# CLASS I SERVICE INSTRUCTIONS

No. 0835-111  
ATA Code 54-10

**SUBJECT:** NACELLES - MODIFICATION OF THE ENGINE FIREWALL

Figure 1.

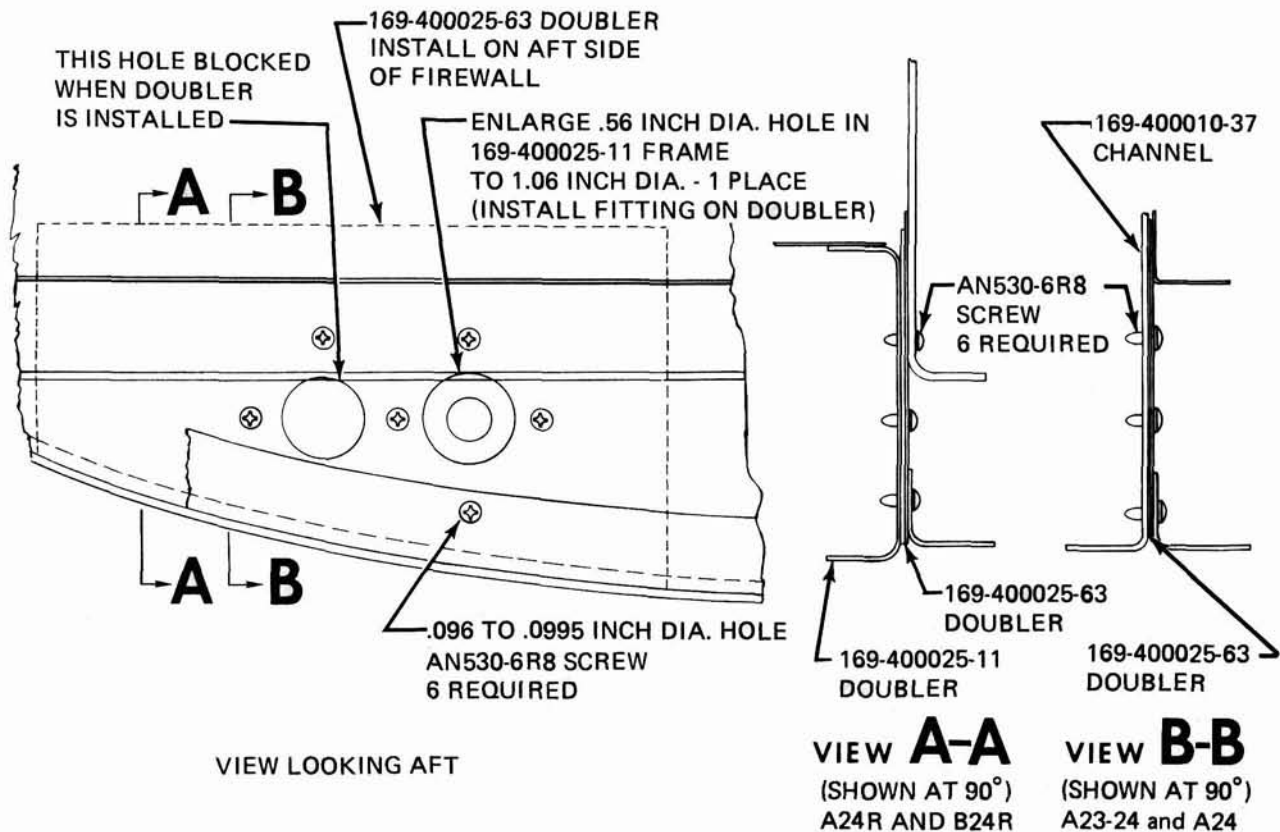
1. For all model A23-24, A24, A24R and B24R airplanes listed under EFFECTIVITY, install the P/N 169-400025-63 doubler between the fuselage frame and the aft side of the engine firewall as shown in figure 1.
2. For all model A23-19, 19A, M19A, B19, B23 and C23 airplanes listed under EFFECTIVITY, install P/N 169-400010-165 doubler on the forward side of the engine firewall as shown in figure 2.
